WELDING INSPECTION REPORT

Report No: WIR-023858
Date Inspected: 18-May-2011

Project Name: SAS Superstructure
Prime Contractor: American Bridge/Fluor Enterprises, a JV
Contractor: Zhenhua Port Machinery Company, Ltd (ZPMC), Changxing Island

Bridge No: 34-0006
Component: OBG

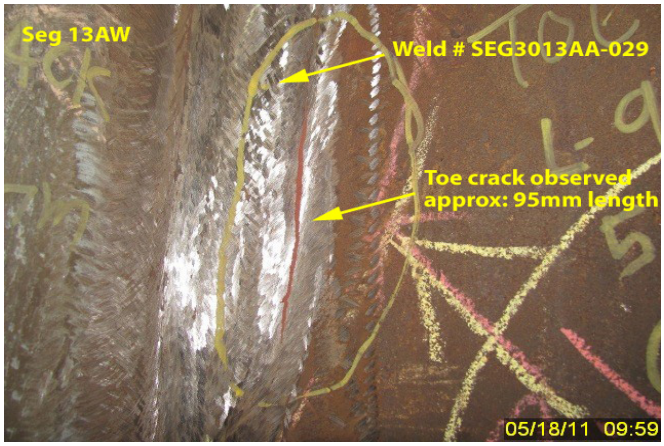
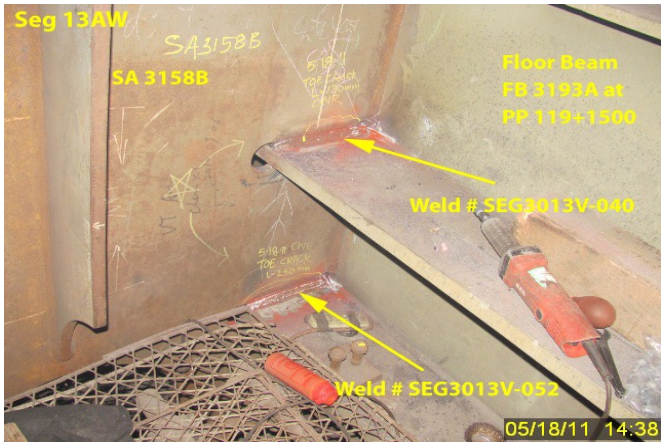
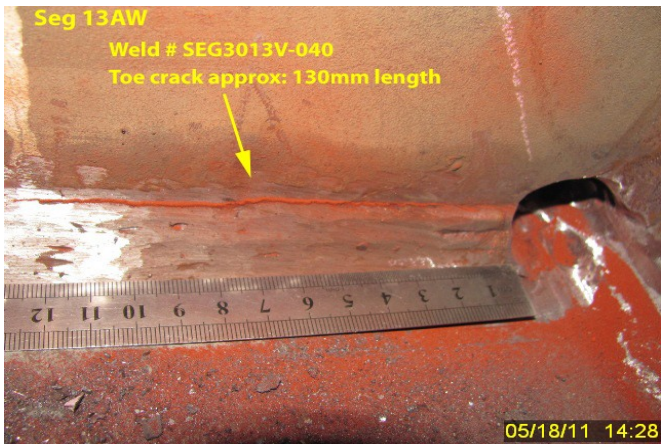
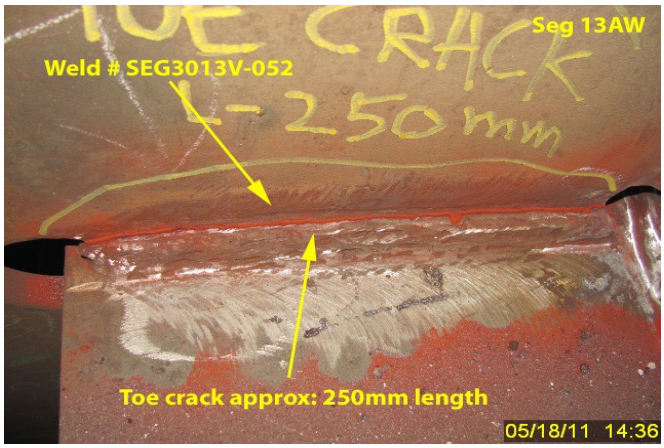
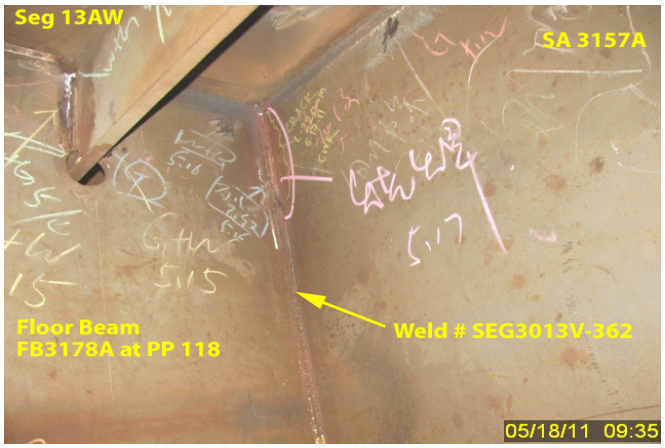
This QA Inspector, along with Mr. Shailesh Wadkar; performed in process Visual Inspection of welds (Seg 13AW) at Panel Points (PP) 117.5, PP118 and PP118.35. Visual Inspection was performed on the welds between Longitudinal Diaphragm (LD) 3034A to Edge Panel (EP) 3023A (on the welds inside of the Segment). At various locations on the EP to FB welds, this QA Inspector observed cope holes that require to be profiled correctly. In addition, the following welds were observed to have toe cracks. Details are as follows:

SEG3013V-040, 052, 362
SEG3013AA-029

This QA Inspector informed to ZPMC CWI, identified as Mr. An Qing Xiang. The weld locations were

documented and forwarded to the CT Lead QA Inspector for further disposition. See attached photo for details.
